Magnolia Public Schools

Ad-Hoc (Facility) Committee Meeting

Approval of Change Order Requests by Oltmans Construction Co. for MSA-1

Ad Hoc Committee Agenda Item #:	II A – Action Item
Date:	December 4, 2019
To:	Magnolia Educational & Research Foundation dba Magnolia Public Schools (“ MPS ”) Ad Hoc Committee (the “ Committee ”)
From:	Alfredo Rubalcava, CEO & Superintendent
Staff Lead:	Patrick Ontiveros, General Counsel & Director of Facilities
RE:	MSA-1 Change Order Requests

**NOT APPROVED - CORRECTION NOTICE**

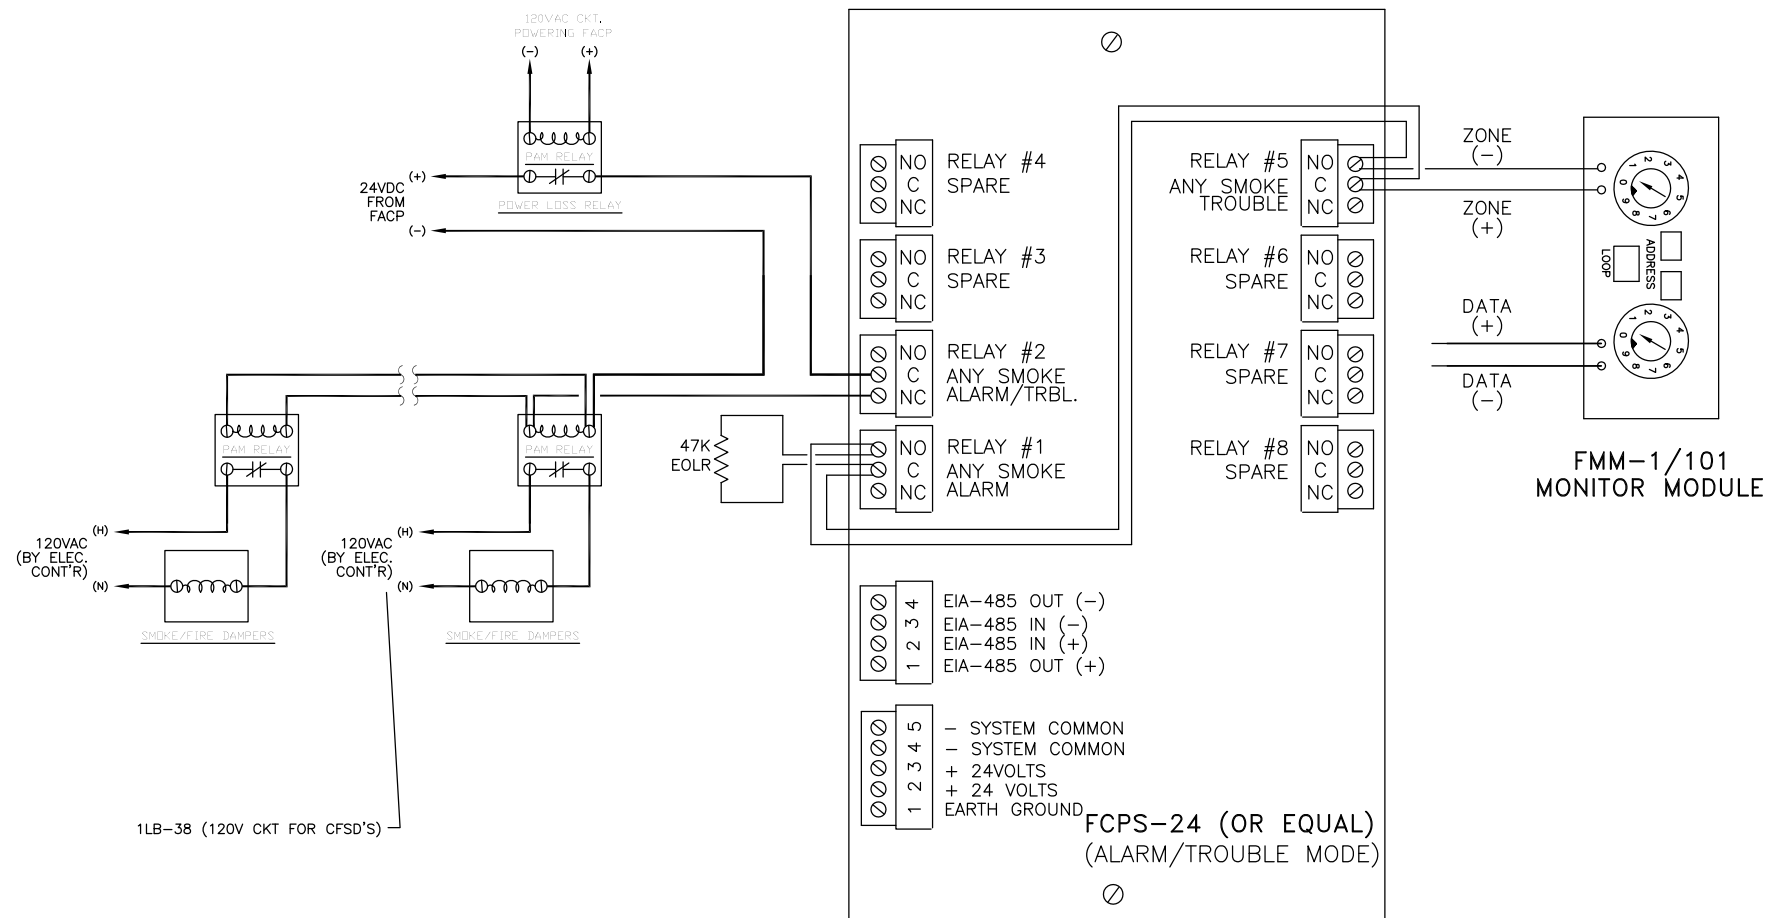
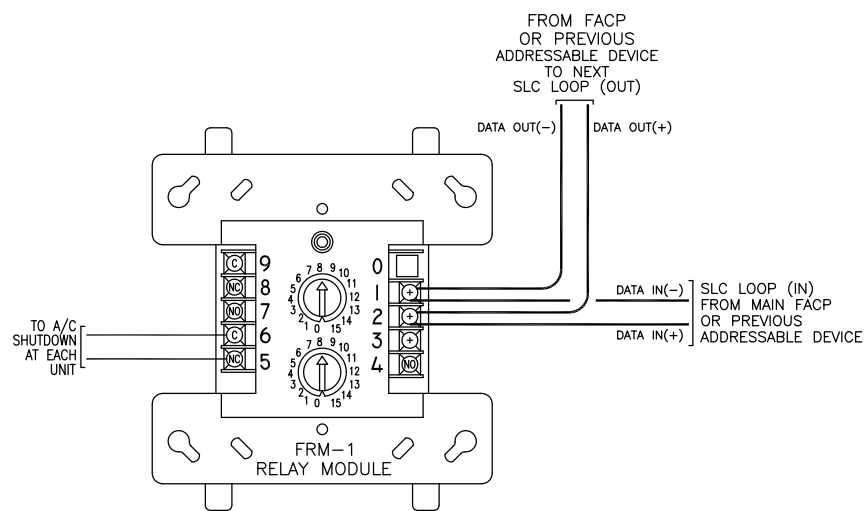
JOB ADDRESS: 18220 W SHERMAN WAY			PERMIT #: 17044-20000-07122	CONFIRM #: 25305989
JOB DESCRIPTION: HVAC			FOR REINSPECTION CALL: (888)LA4-BUILD or 311 INSPECTOR: KEVIN BROWN DISTRICT: HVACVN1 PHONE: (818) 374-1153 BUREAU: Inspection Bureau DATE: 8/13/2019	
APPLICANT/AGENT: CHRISTIAN BROTHERS MECHANICAL SERVICES INC				
ADDRESS: 11140 THURSTON LANE				
CITY: MIRA LOMA	STATE: CA	ZIPCODE: 91752		
<p>Before the work or installation authorized by this permit can be approved, concealed, energized, or used, the following deficiencies shall be corrected. Call for reinspection when all corrections have been made.</p>				
<p>PERMIT GROUP/TYPE/SUBTYPE: Mechanical/HVAC/Commercial INSPECTION TYPE: VENTILATION-Final</p>				
<p>VIOLATION NUMBER: 19-DMN-141-G-3346 Date Issued: 8/14/2019 Issued by</p> <p>VIOLATION TYPE: LAMS Smoke/Fire Damper Smoke Detection</p> <p>VIOLATION CODE SECTION: 95.606.1 LAMC</p> <p>CODE LANGUAGE: Provide duct detector within 5 feet of each smoke/fire damper in the airstream or provide full area coverage (716.3.2.1 CBC).</p> <p>VIOLATION NOTES: Second</p>

<p>VIOLATION NUMBER: 19-DMN-141-G-3410 Date Issued: 8/14/2019 Issued by</p> <p>VIOLATION TYPE: Fan Shutdown</p> <p>VIOLATION CODE SECTION: 95.609.0 LAMC</p> <p>CODE LANGUAGE: Provide duct detector in the main supply air plenum of all air moving systems in excess of 2000 CFM combined, such systems shall shutdown simultaneously without delay.</p> <p>VIOLATION NOTES: Second</p>

DATE: 03-04-19
SCALE: AS NOTED
DRAWN BY: --
CHECKED BY: --
JOB NUMBER: 18-3023
SHEET NUMBER: **SD-2.0**

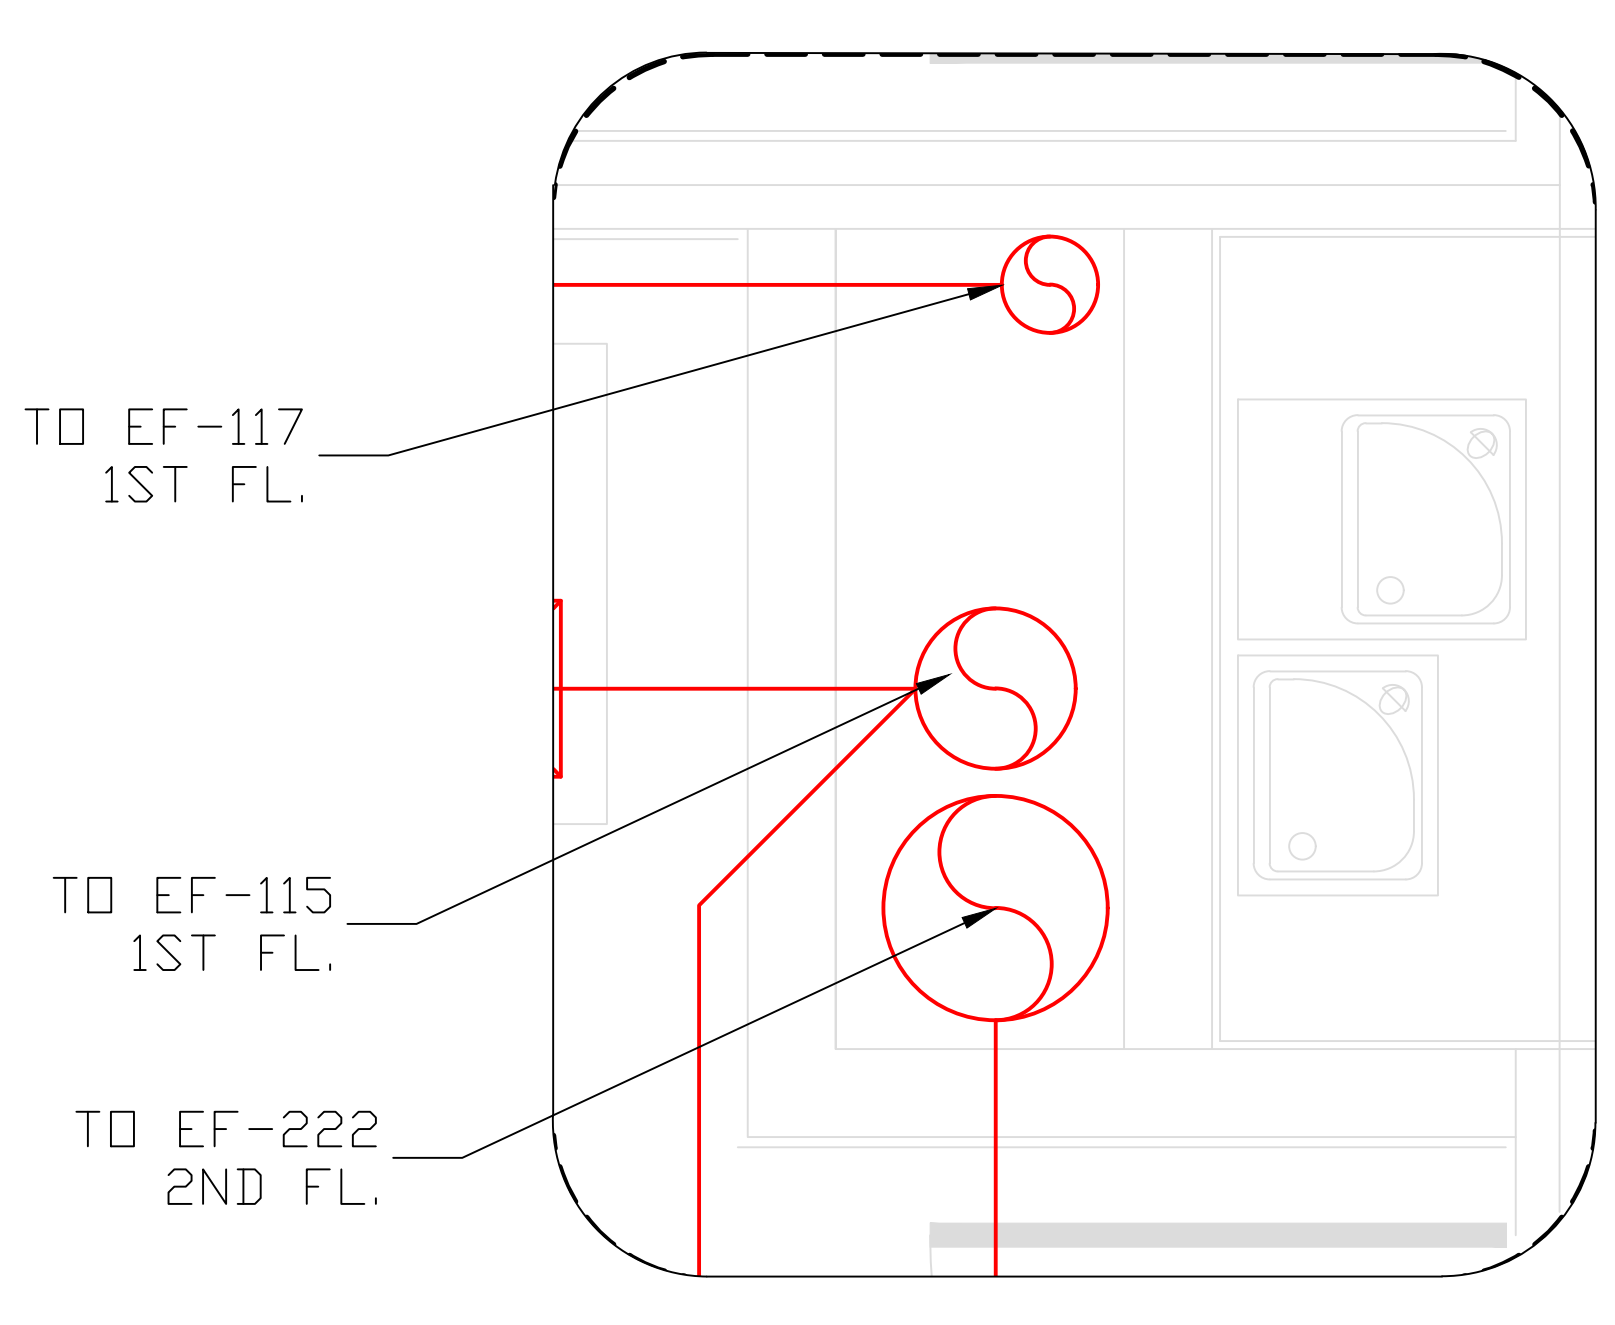
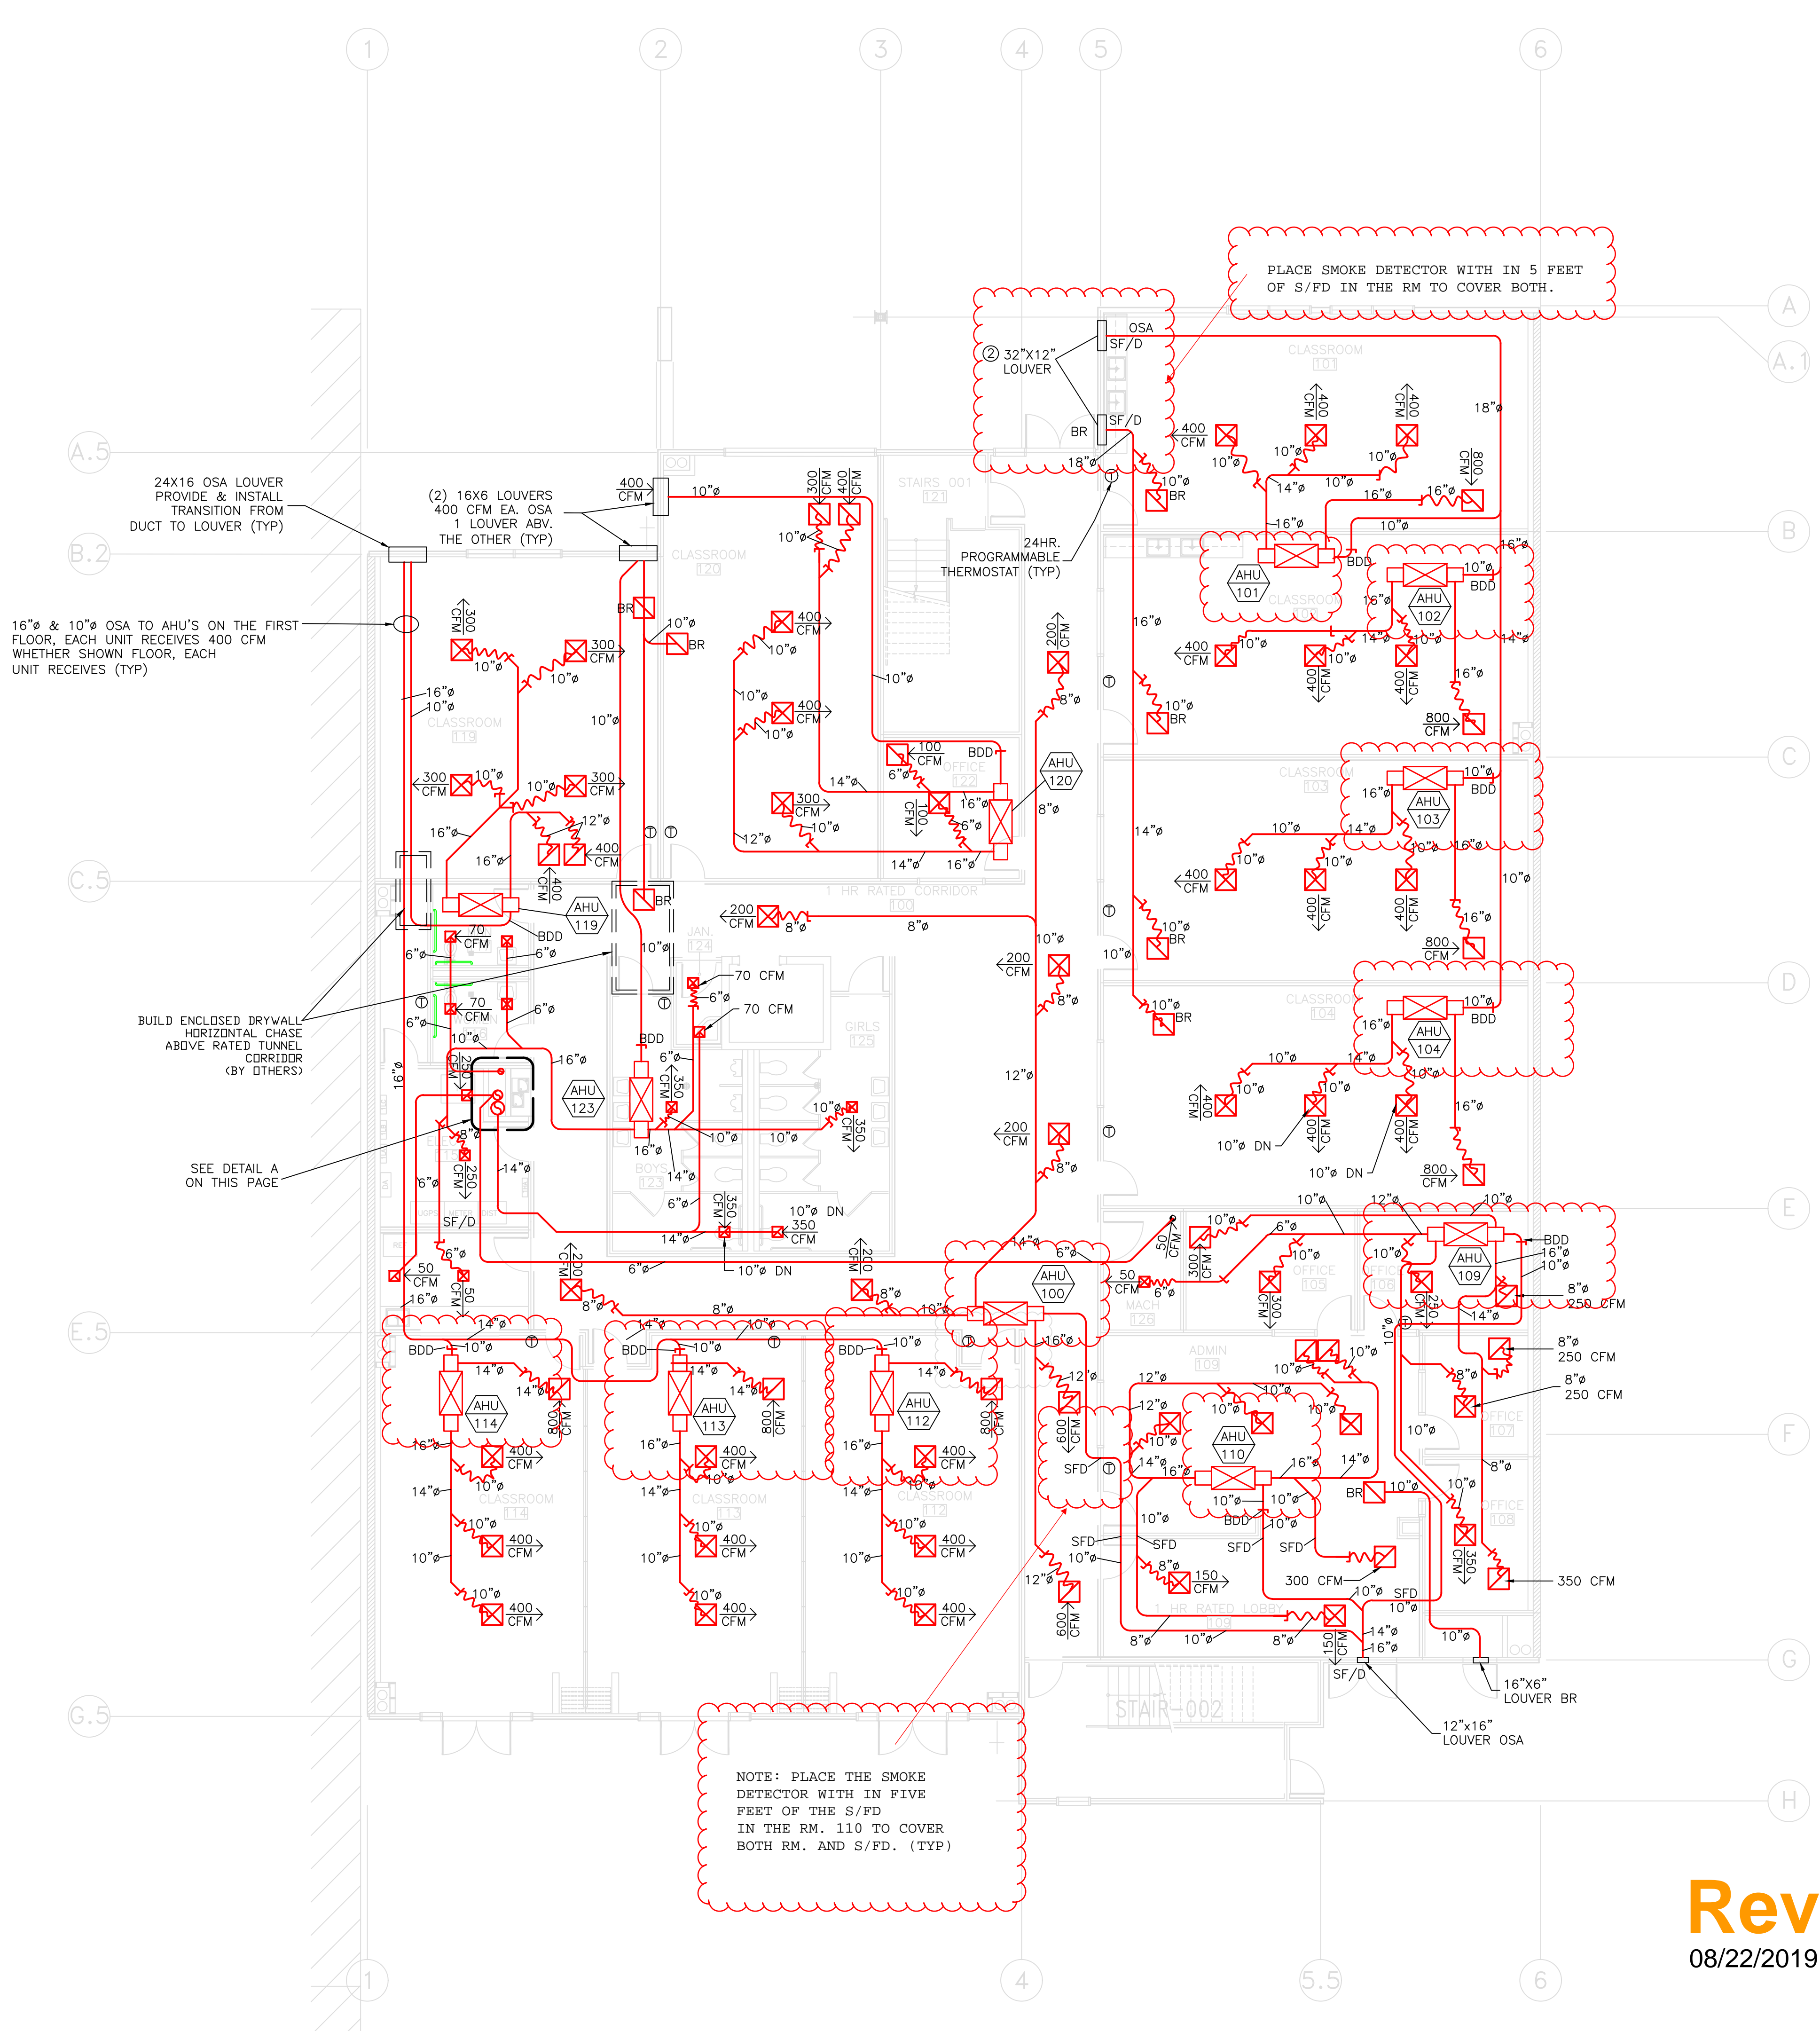
1. From shop drawing SD-2.0, rooms 100,101,102,103,104,110,1109,112,113,114. From shop drawing SD-3.0, 1 smoke detector is required within five feet of the smoke/fire damper shown on the plan I've attached and the s/fd clouded.
2. Shut down all the units as indicated in 1.
3. Duct detectors are not required.
4. Yes, on the second floor SD-3.0, near kitchen, see clouded.
5. Yes.
6. Only in room 109. return air from any of the other room will reach rm. smoke detector.
7. Smoke detector in corridor, second near kitchen will suffice.
- Date:** 8. Confirmed. Please verify with electrical.
